# **UNIVERSITY OF MISSOURI RESEARCH REACTOR**

## **REACTOR OPERATIONS ANNUAL REPORT**

**1 January 1996 - 31 December 1996**

1995 Revision to Original HSR, Figure 3.1:

Figure 3.1  
Basement Level

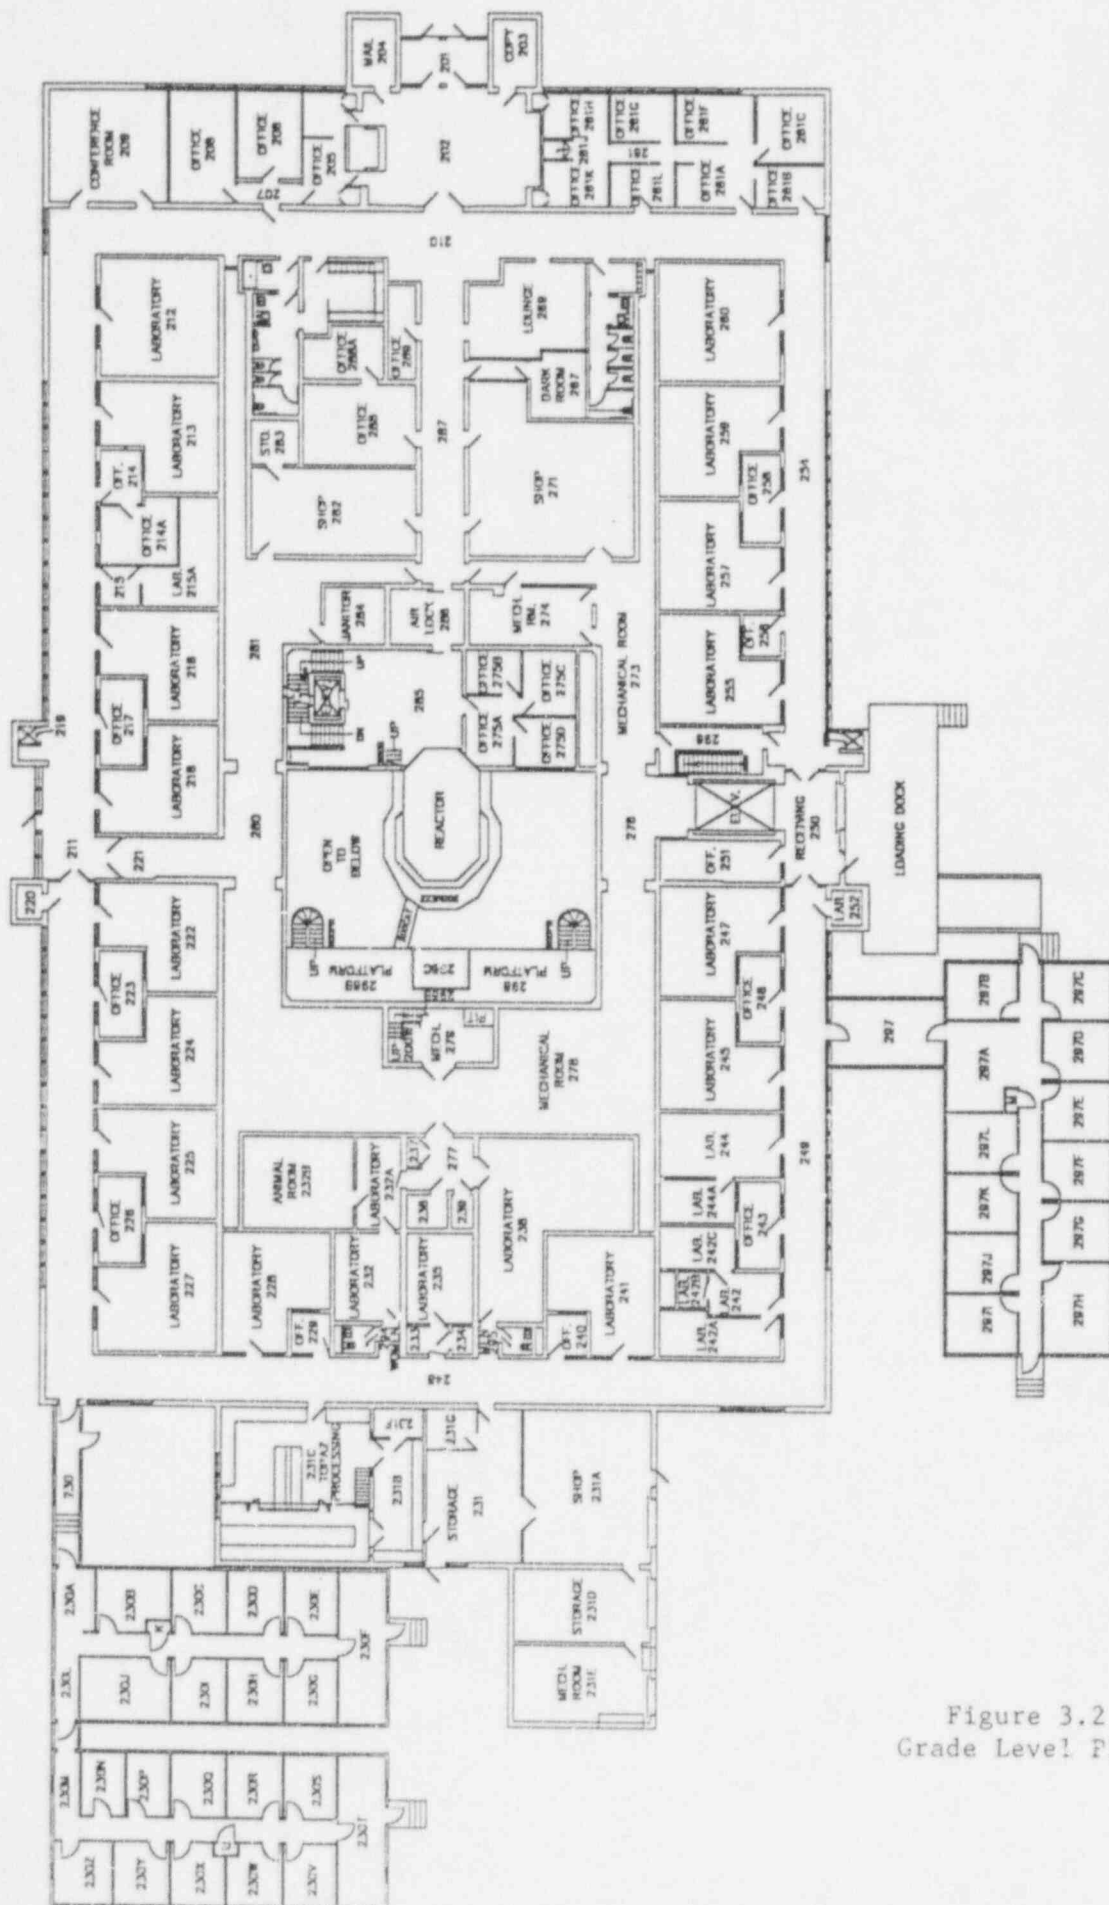
Replace with: Updated Figure 3.1--Basement Level (MURR Dwg #2269, Sheet 1 of 5, dated 12/19/95)

Figure 3.3.a.  
Third Floor Plan

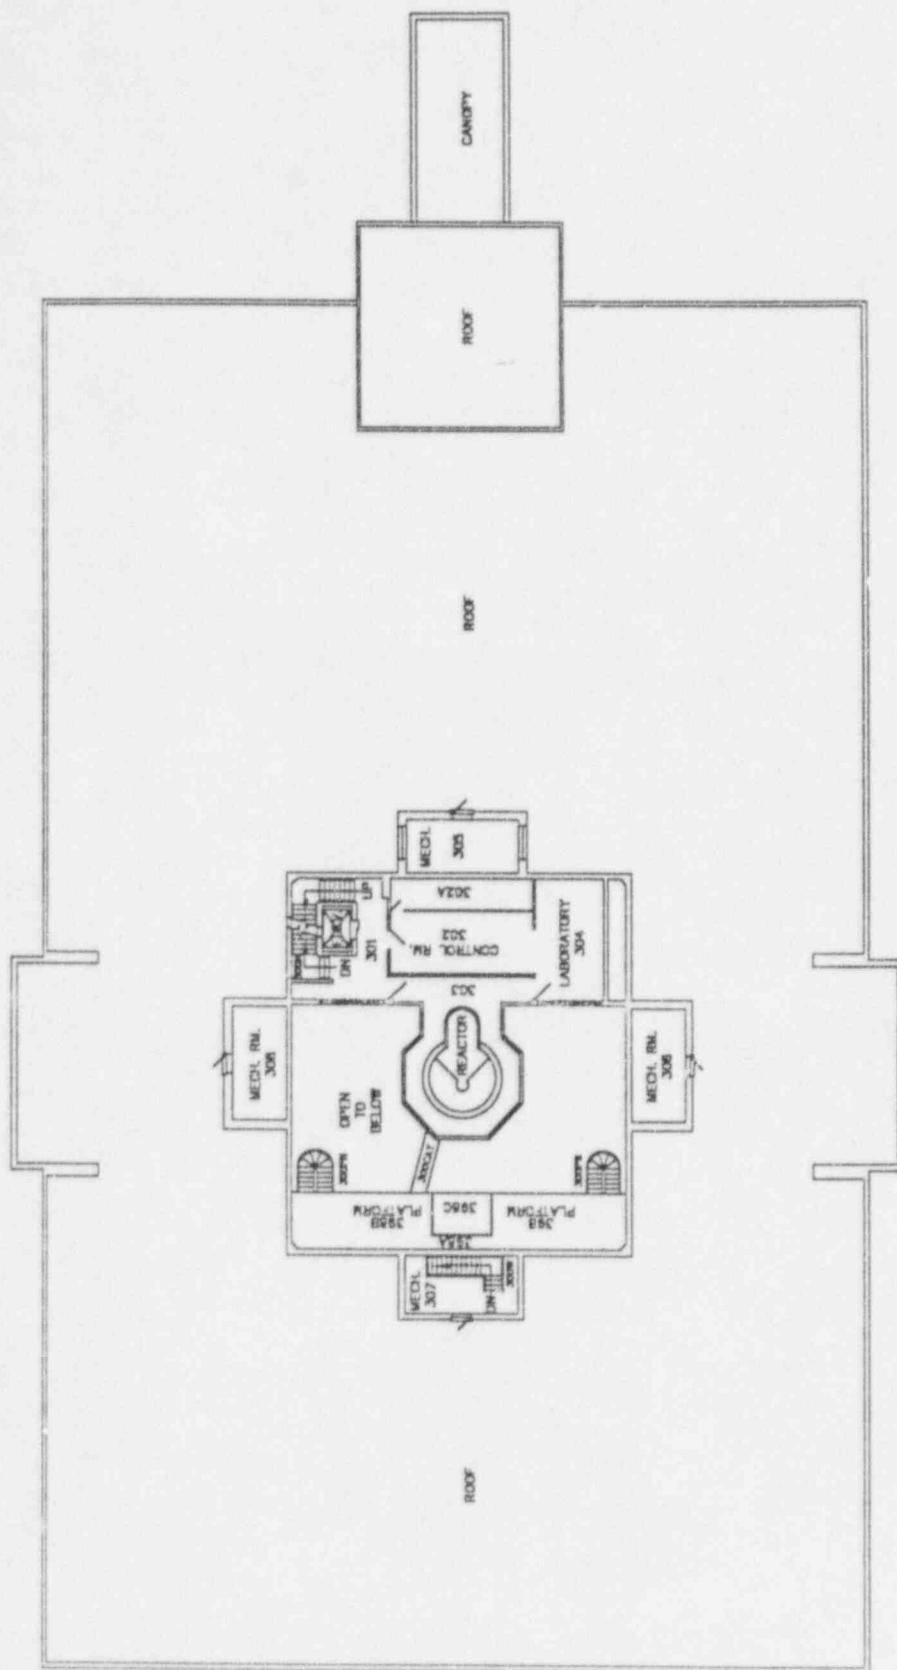
1995 Revision to Original HSR, Figure 3.3:

Updated Figure 3.3.a--Third Floor Plan (MURR Dwg #2269, Sheet 3 of 5, dated 12/19/95)

Figure 3.3.c  
Fifth Floor Plan

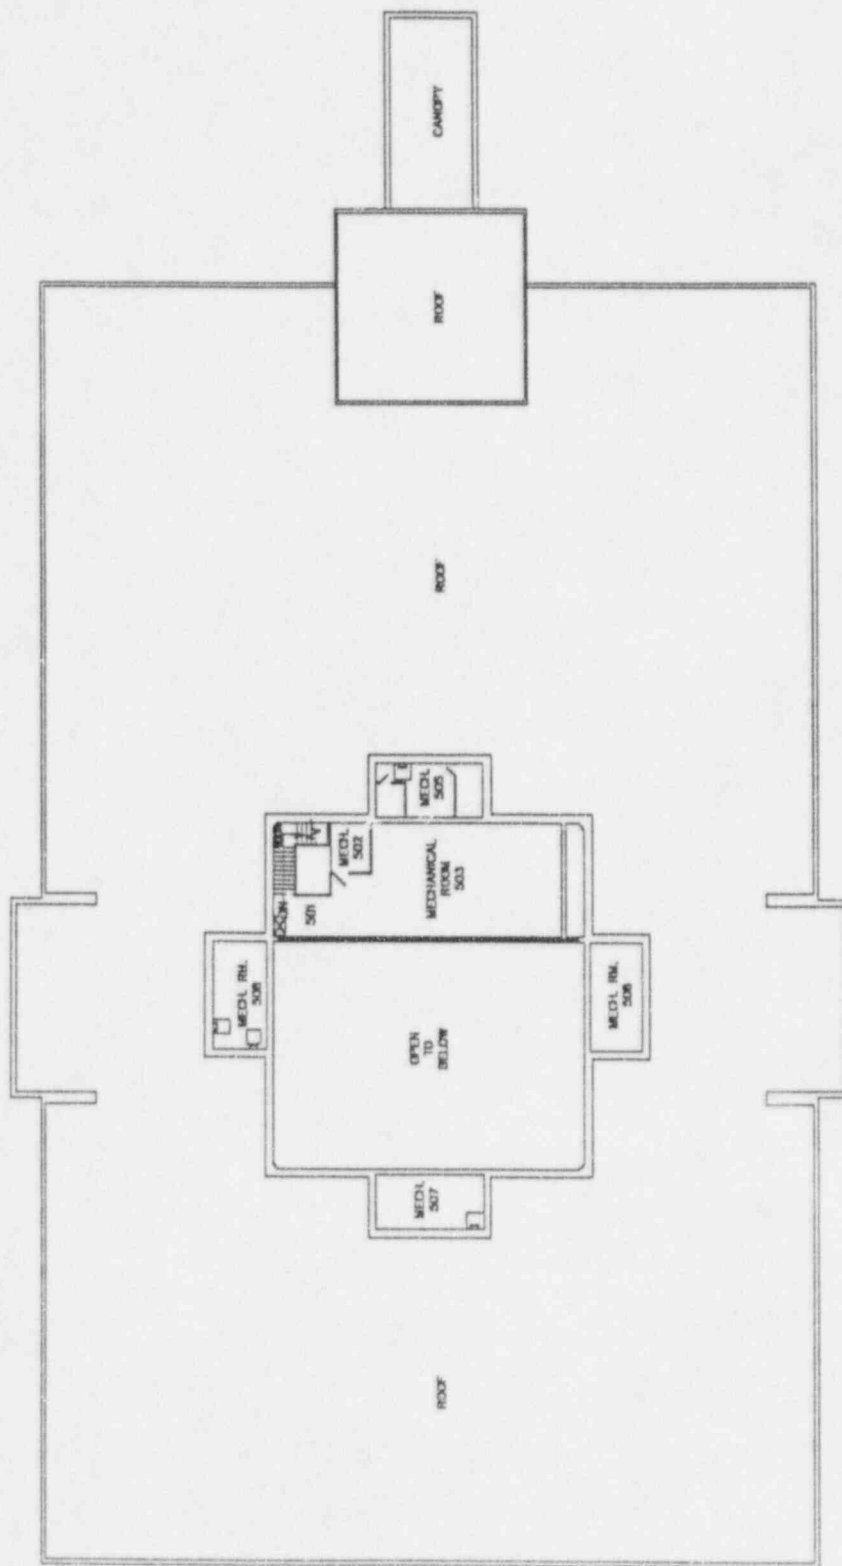
Updated Figure 3.3.c--Fifth Floor Plan (MURR Dwg #2269, Sheet 5 of 5, dated 12/19/95)

Figure 3.8  
COOLING TOWER AT GRADE LEVEL - PLAN VIEW  
(Rev. 5/20/96)

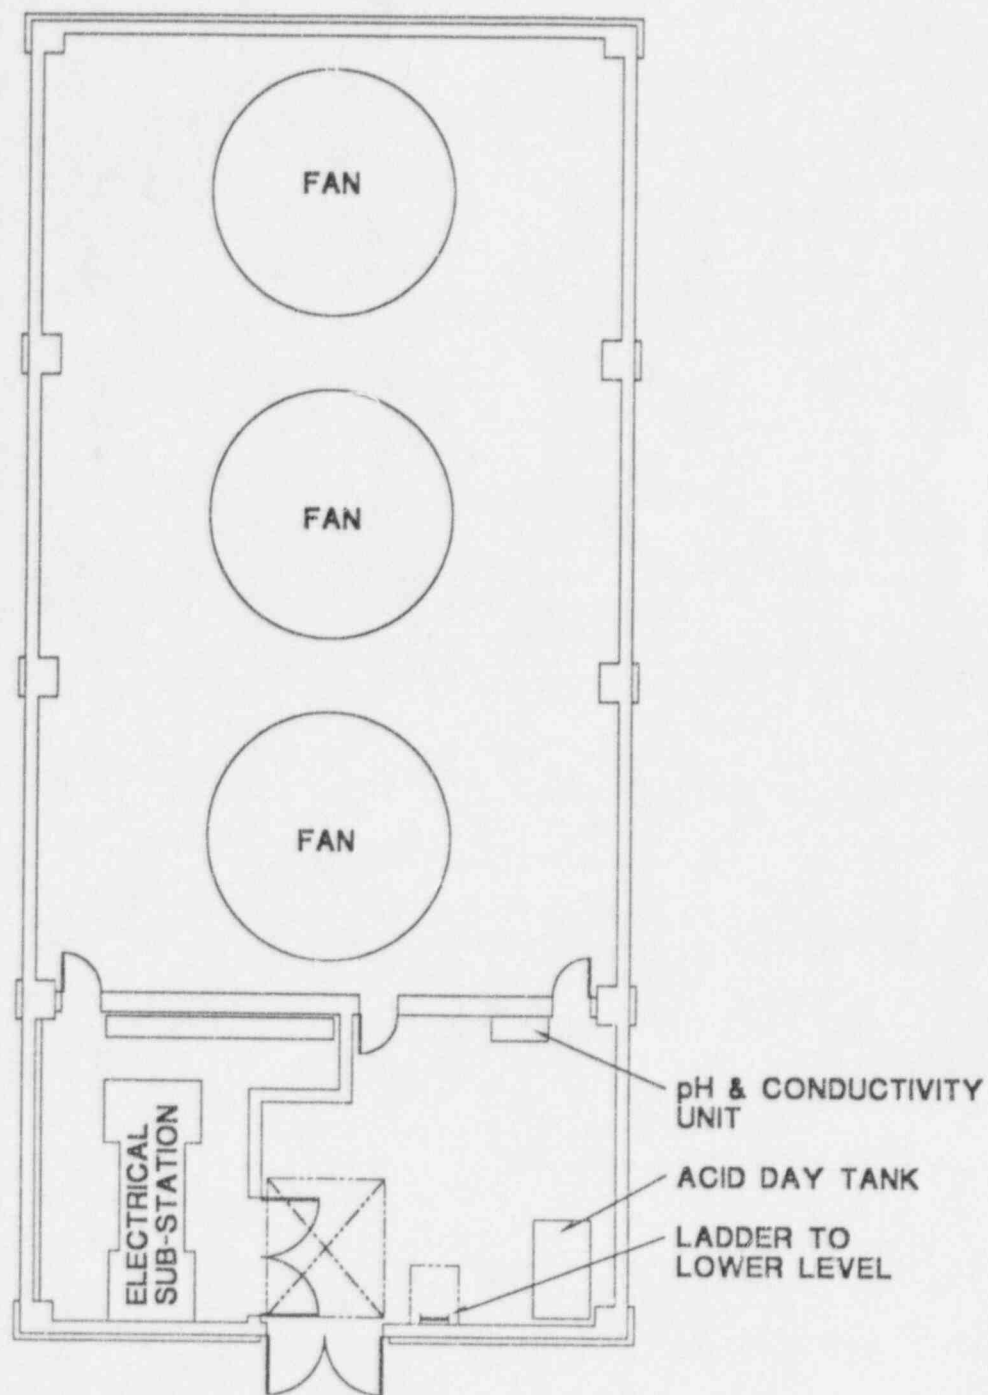
1995 Revision to Original HSR, Figure 3.8:

Replace with: Updated Figure 3.8--Cooling Tower Building at Grade Plan (dated 5/20/96)

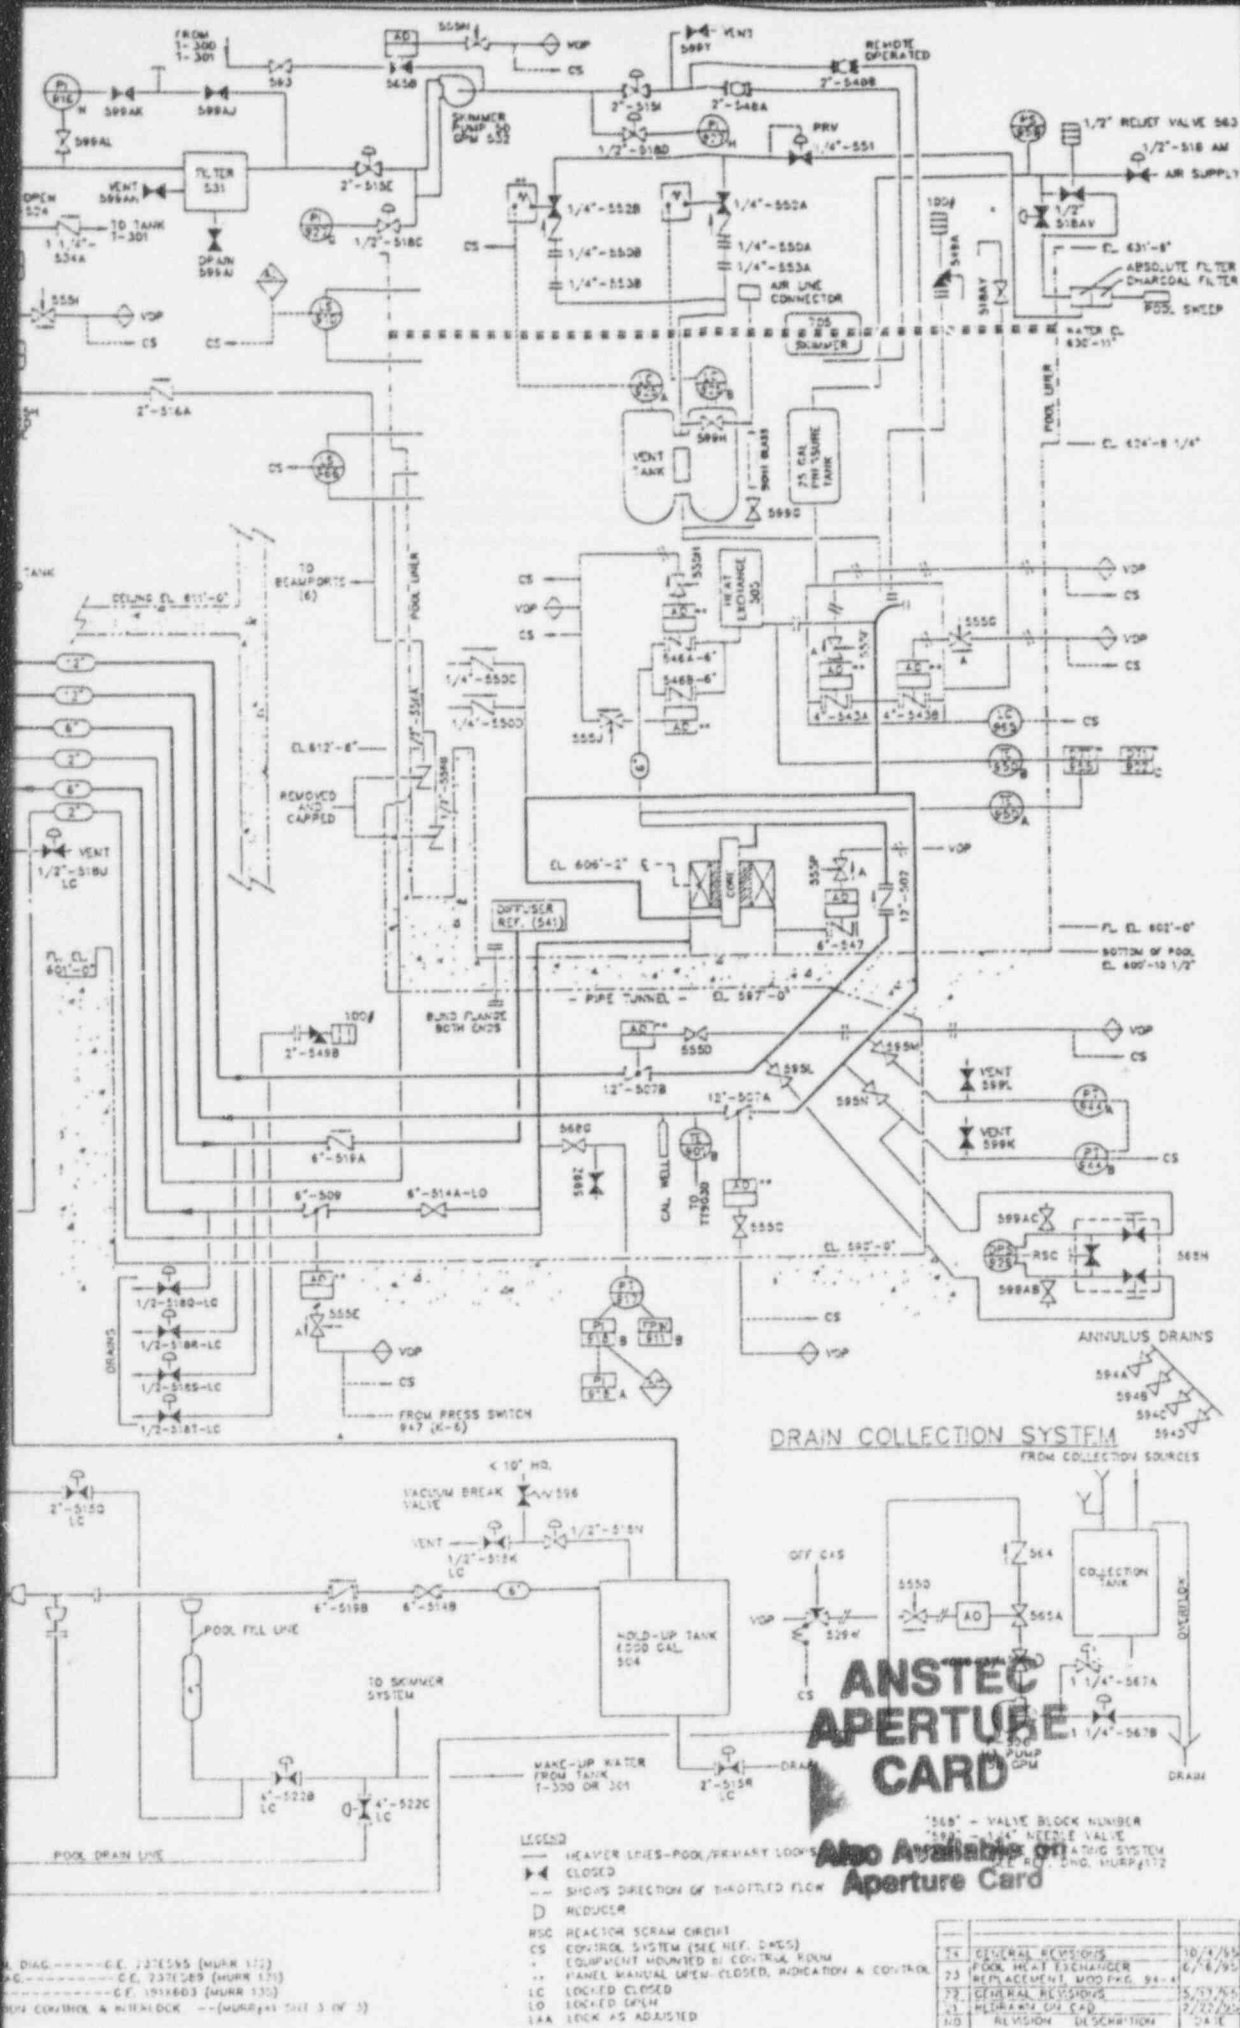
Original HSR, Figure 5.1:

Replace with: Updated Figure 5.1--Piping & Instrument Diagram (MURR Dwg #156, dated 10/4/95)

Figure 8.1

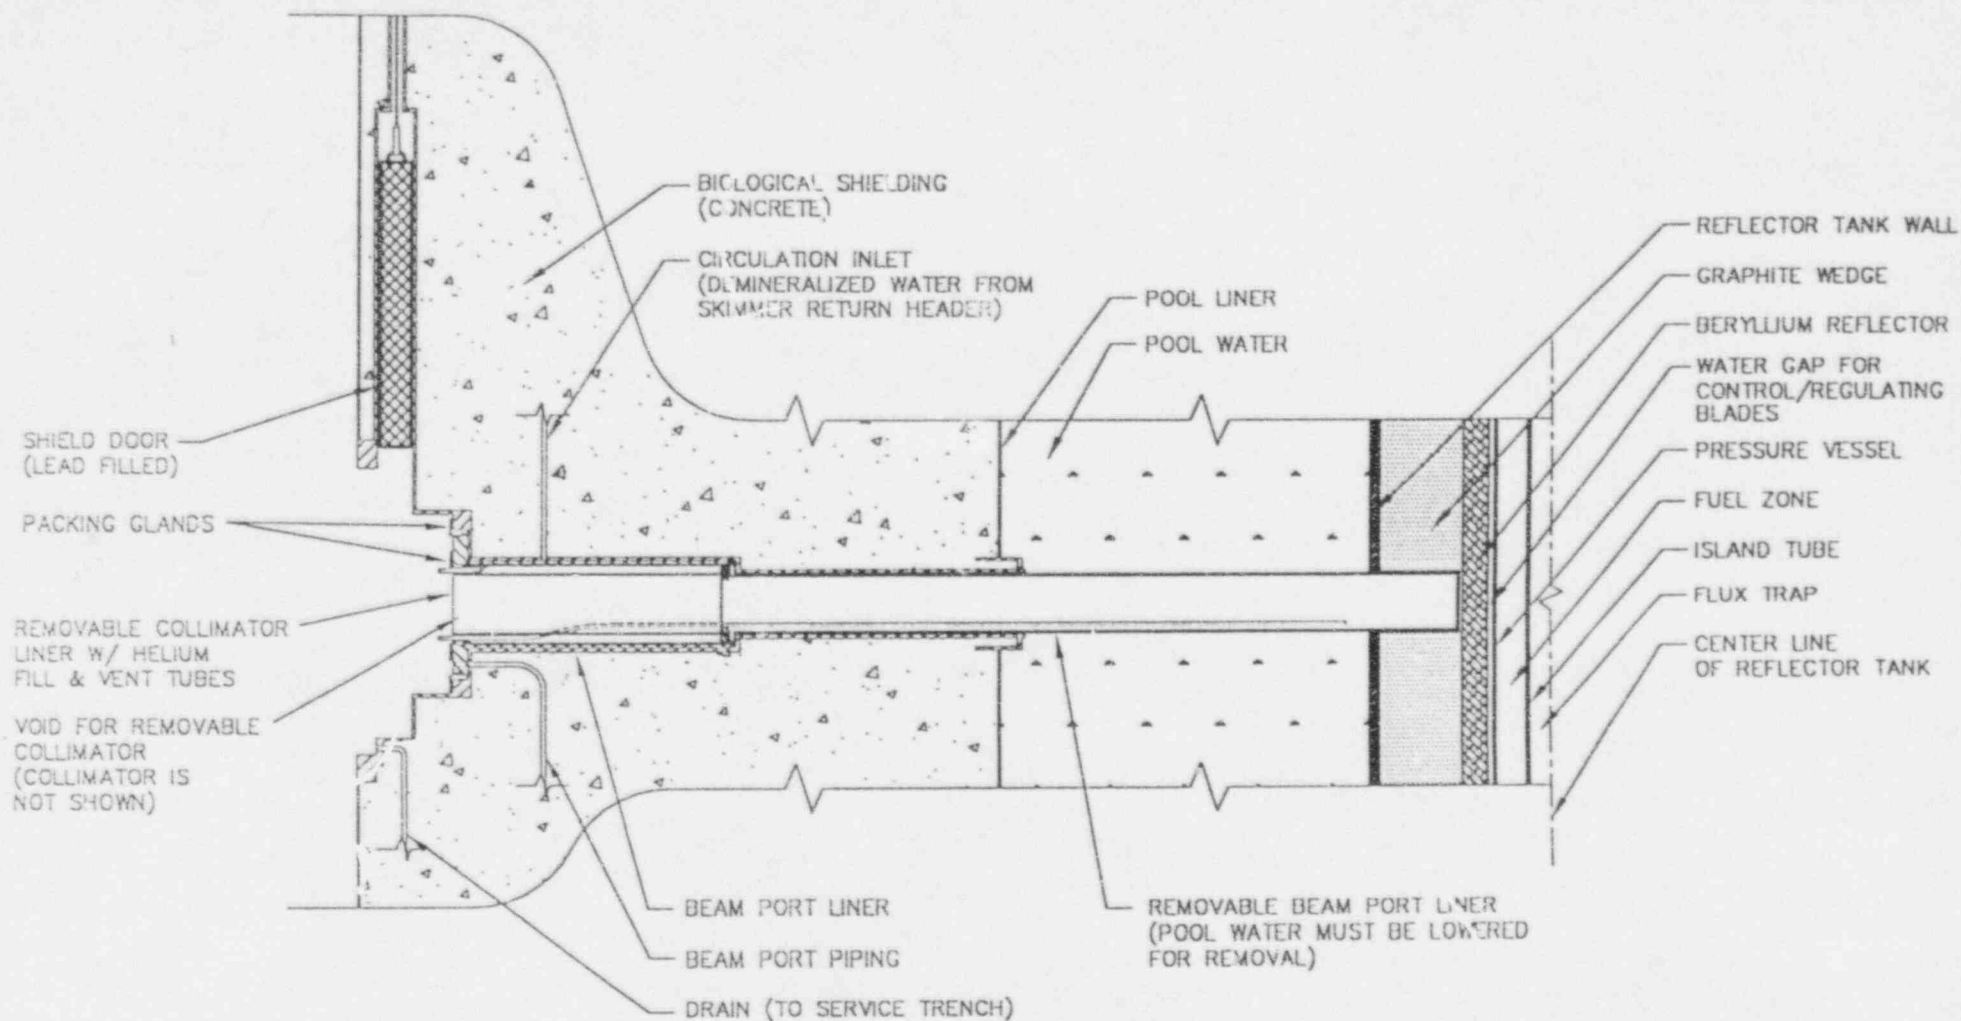
Original HSR, Figure 8.1, Beamport Assembly:

Replace with: Updated Figure 8.1, Beamport Assembly (dated 11/15/96)
